SUBSURFACE WASTEWATER DISPOSAL SYSTEM APPLICATION

Town Or Plantation: Augusta
Street: Old Belgrade Road
Subdivision Lot #: Tax Map # 80 Lot # 19

SUBJECT: Replacement System Variance approval, Construction Specialties, Inc. property, Old Belgrade Road, Augusta

SUBSURFACE WASTEWATER DISPOSAL PLAN

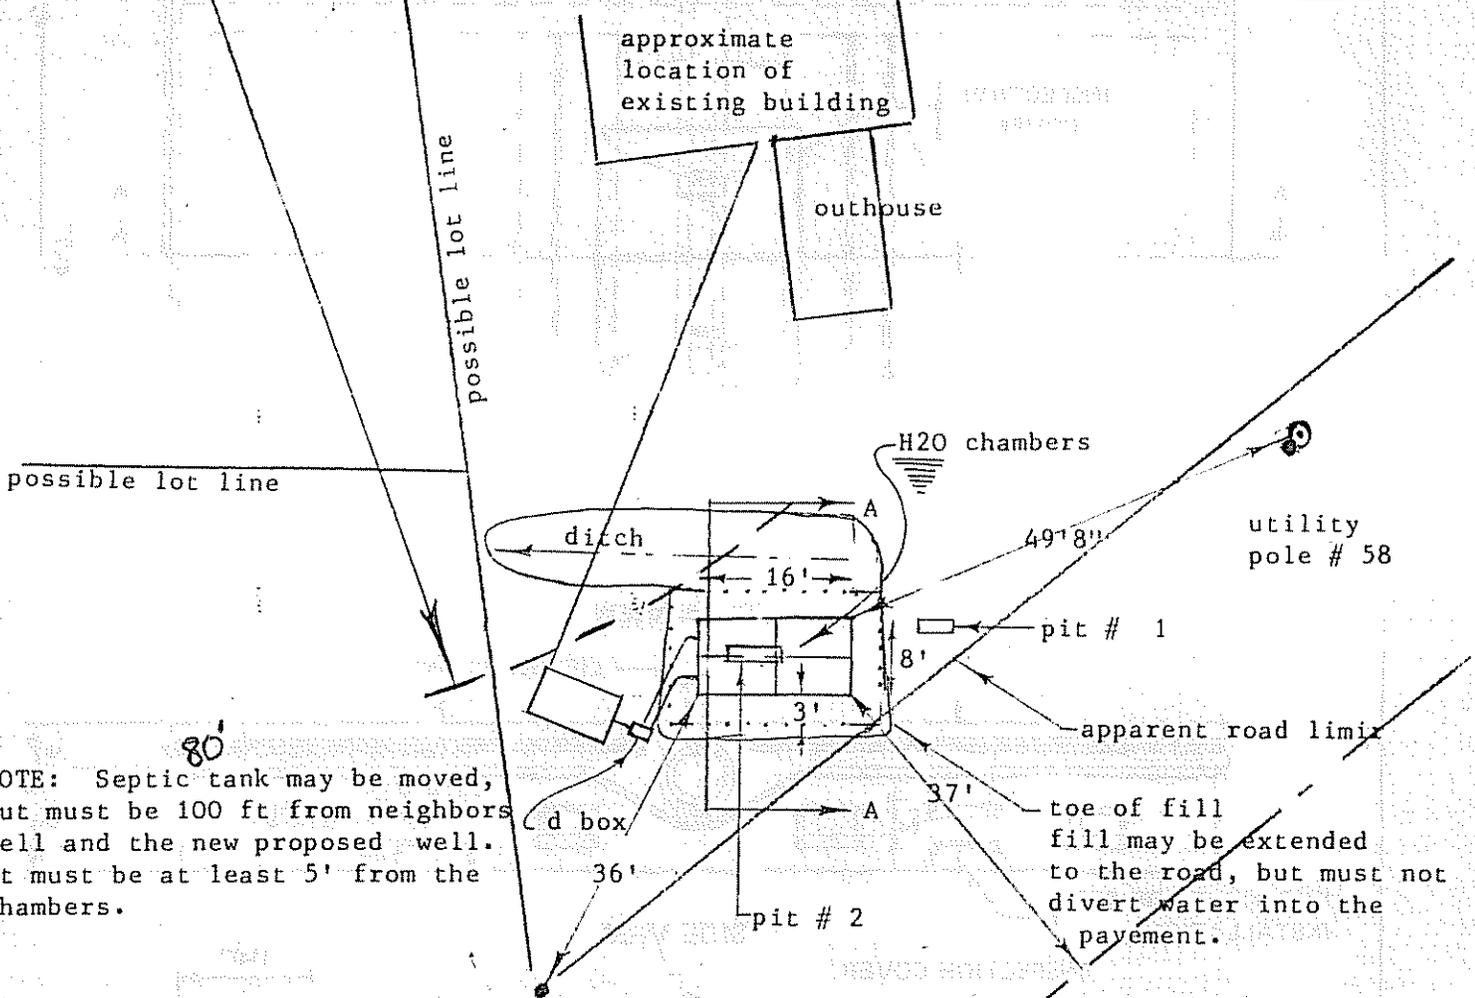
NOTE: Septic tank may be moved, but must be 100 ft from neighbors well and the new proposed well. It must be at least 5' from the chambers.

DISPOSAL AREA CROSS SECTION

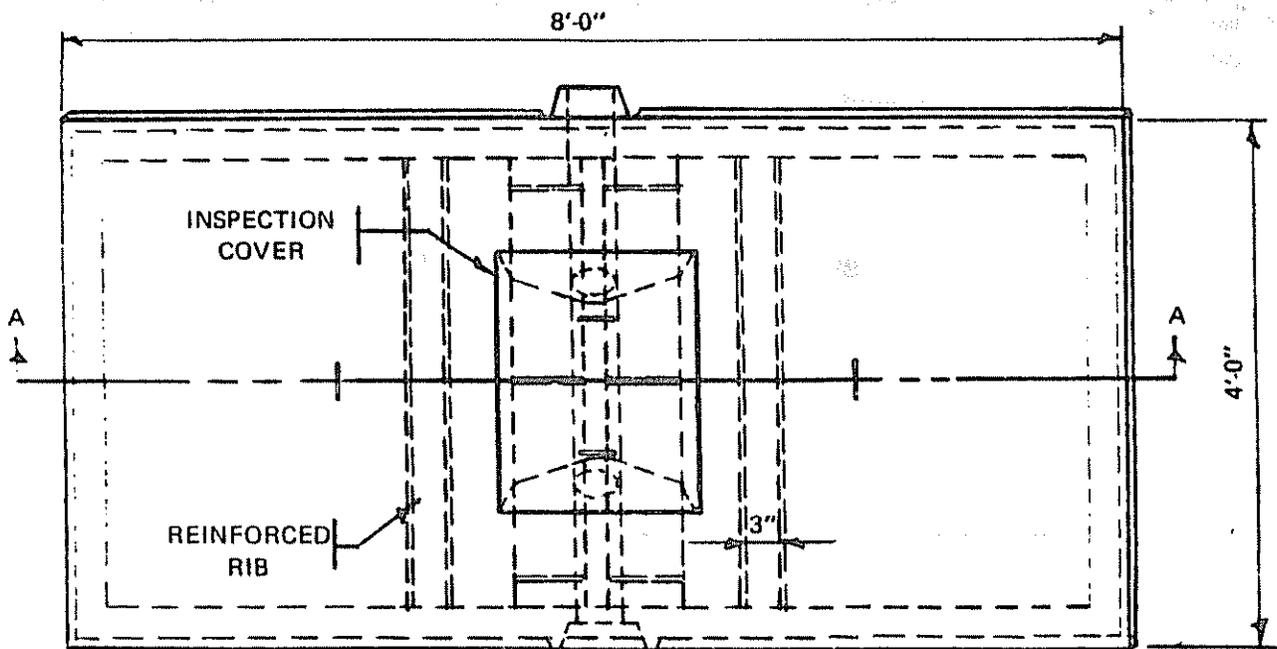
NOTE: The driveway for the new building will probably pass over this system. If it does, 2" of foam insulation is recommended on the top of the chambers.
